REMARKS

VERSION WITH MARKINGS TO SHOW CHANGES MADE

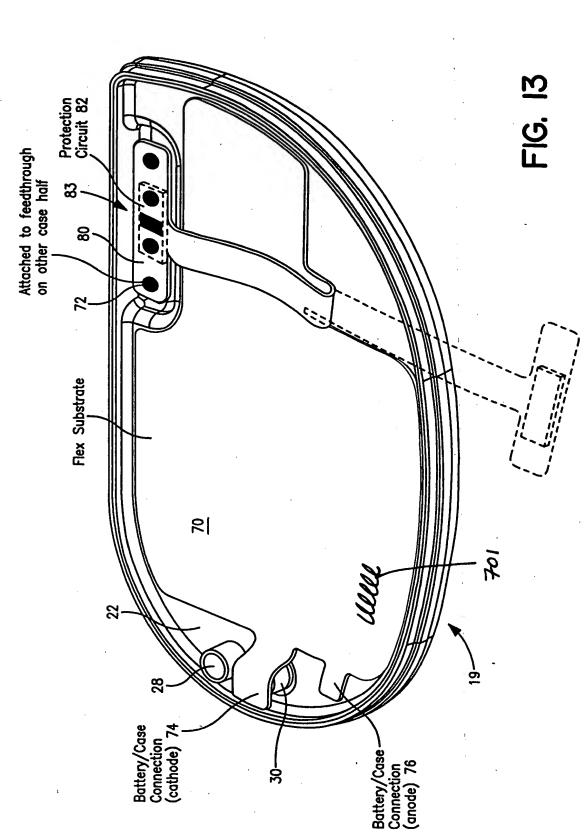
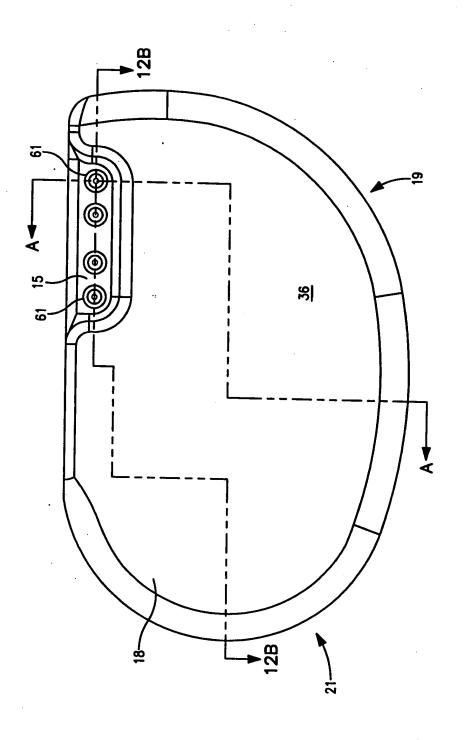
The drawings stand objected to under 37 CFR 1.83(a). Attached herewith is the drawing for Figure 13 showing proposed changes in red for approval by the

Examiner per 37 CFR 1.121(d). According to the request of the Examiner, the proposed changes show the antenna as item 701 coupled to or embedded into the deformable flexible substrate. Additionally, paragraph 2 on page 22 has been amended to identify an antenna coil as item 701. Accordingly, Applicants respectfully request that the objection to the drawings be withdrawn.

Attached herewith is the drawing for Figure 13 showing proposed changes in red for approval by the Examiner per 37 CFR 1.121(d).
